(1) Insights concerning "Supply lines for additional TPRDs"

Source: Document from the 14th GRSP TF on the transposition of GTR 13 Phase 2 to UN R 134, dated 10/07/2023~12/07/2023

(2) Insights concerning "The number of hydraulic sequential tests conducted"

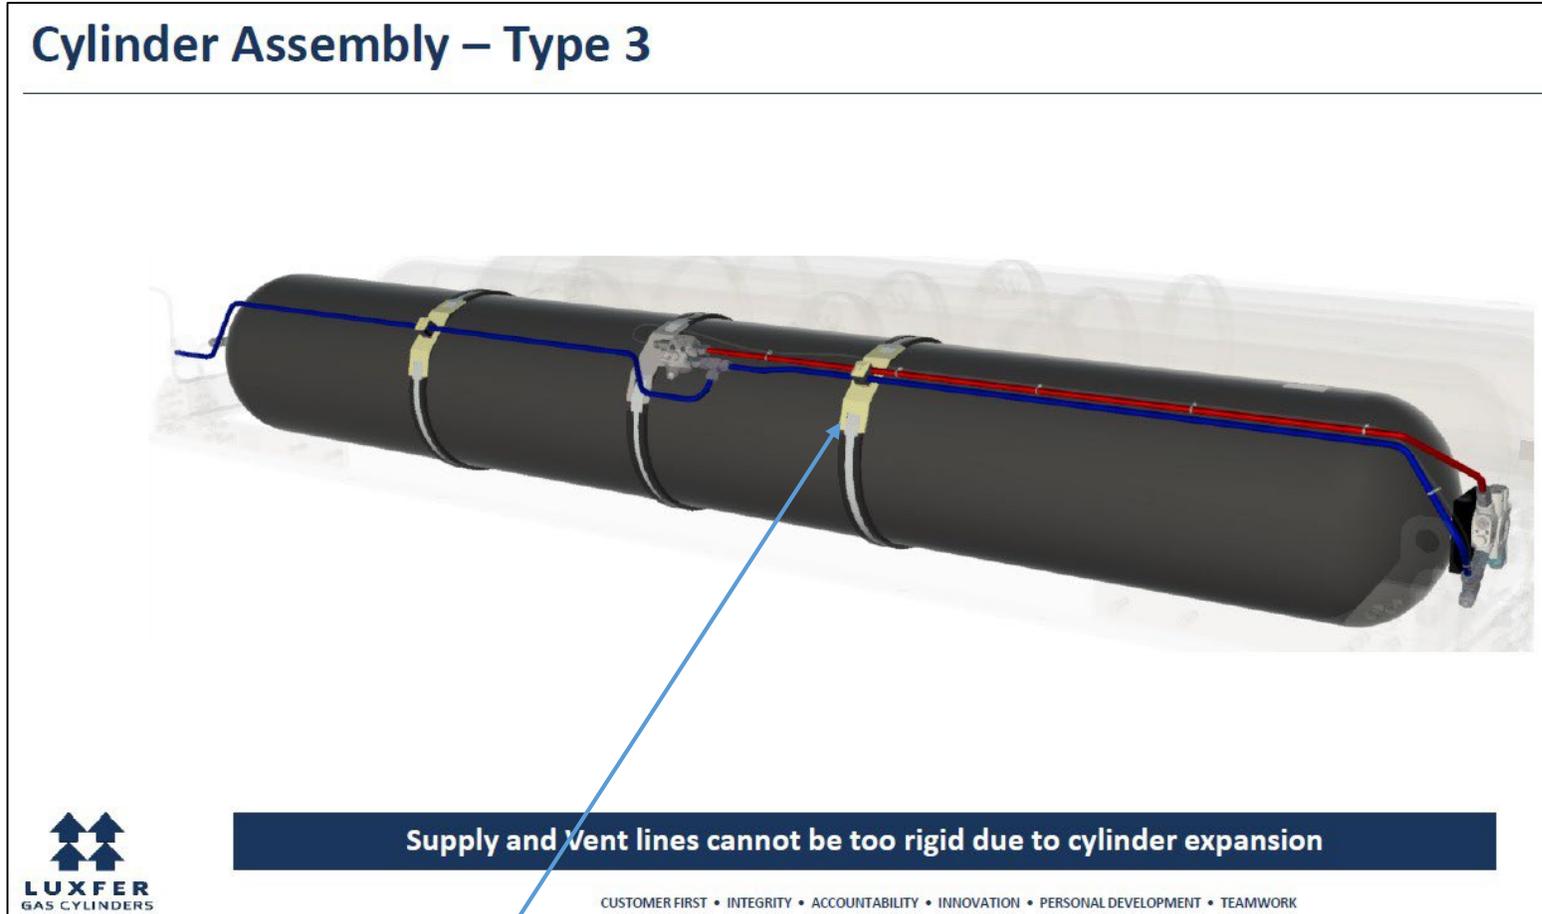
This parts is considered that provide additional support and/or protection to the supply lines for additional TPRDs. In the current proposal, this parts is not included in the definition of CHSS but may be used for each test such as Verification tests for performance durability.

It is necessary to consider whether this parts should also be defined together with supply lines for additional TPRDs or not.
